MEMORANDUM

REVIEW TYPE: Site Plan Review
CASE #: 8-03020
PROJECT NAME: Tony's Carwash
APPLYING FOR: Approval of 9,329 sf commercial space for automobile washing service
Waiver of setback [59-C-4.367]
REVIEW BASIS: Site Plan Review is required for the C-3 Zone [C-4.36]

ZONE: C-3
LOCATION: Germantown Road (MD118), 600 feet north of Wisteria Drive
MASTER PLAN: Germantown Master Plan, 1989
APPLICANT: CTG OTL, Inc.
FILING DATE: April 23, 2003
HEARING DATE: May 15, 2003

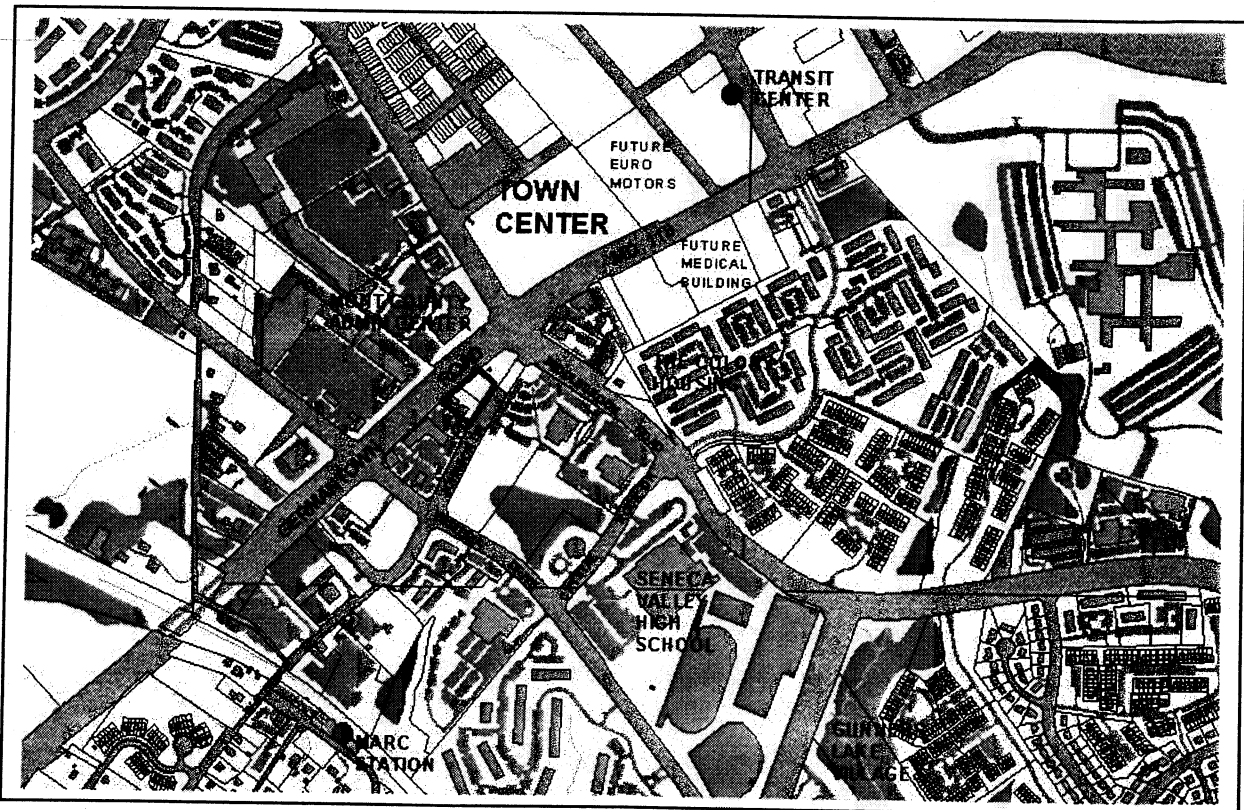
Applicant Position: Applicant proposes Willow Oaks for the MD118 median west of Wisteria Drive.

Staff Recommendation: Subdivision and Site Plan staff supports the provision of trees in the median and along the south curb.

Proposal for Tony's Carwash showing vehicular ingress and egress from Walter Johnson Road

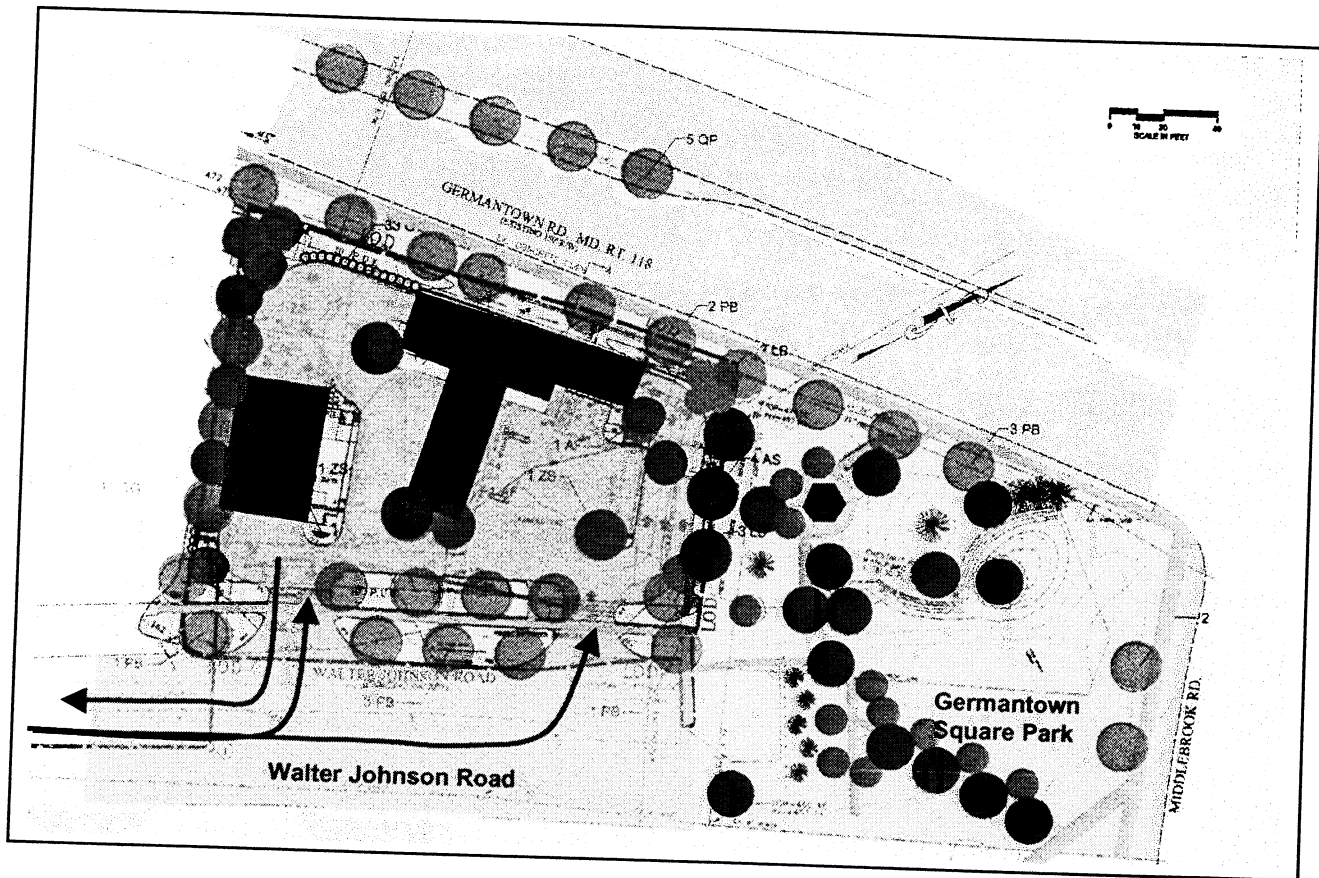
The proposed full-service car wash offers an enclosed automatic car-wash tunnel situated parallel to Germantown Road, a separate building at the south end of the site for interior vehicle cleaning, and four self-service car wash bays in the center of the site. The automatic wash tunnel is capable of processing 100 to 150 cars per hour. The proposed hours of operation are 7 am to 7 pm on weekdays and 9 am to 5 pm on weekends. The applicant anticipates that he would need no more than five to seven employees to operate the facility even during peak hours.

Detail showing locations of the noise wall for the park and the noise wall recommended by staff for the sidewalk on Germantown Road

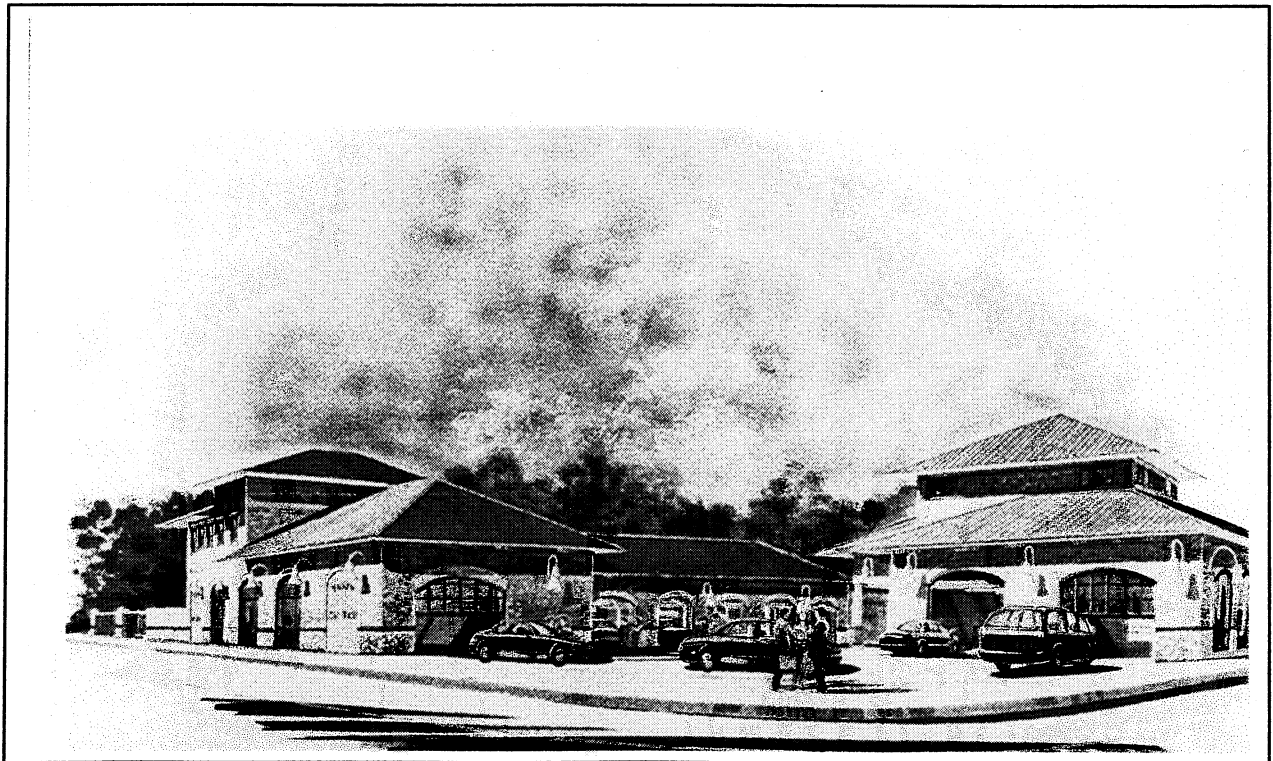
Noise emanating from the car-drying blowers will negatively impact pedestrians walking along the public sidewalk between the subject property and Germantown Road. The existing sidewalk is 30 feet from the proposed location of the car wash tunnel and the noise intensity at this location would be greater than 65dBA. Noise from the adjoining roadway has been measured at peak traffic hours at 70-93dBA at a distance of 10 feet from the roadway pavement. Even though the highway noise reaches higher decibel levels, the duration is typically short. In contrast, pedestrians walking along the car wash frontage would be subject to the blower noise for the entire length of the site, with an increase in decibel levels occurring nearest the car wash exit tunnel.

Staff Position: The Environmental Planning Staff recommends mitigation of the noise that will impact this primary pedestrian axis within the Germantown Town Center. Staff recommends that the applicant construct an attractive short segment masonry noise wall of compatible materials and style.
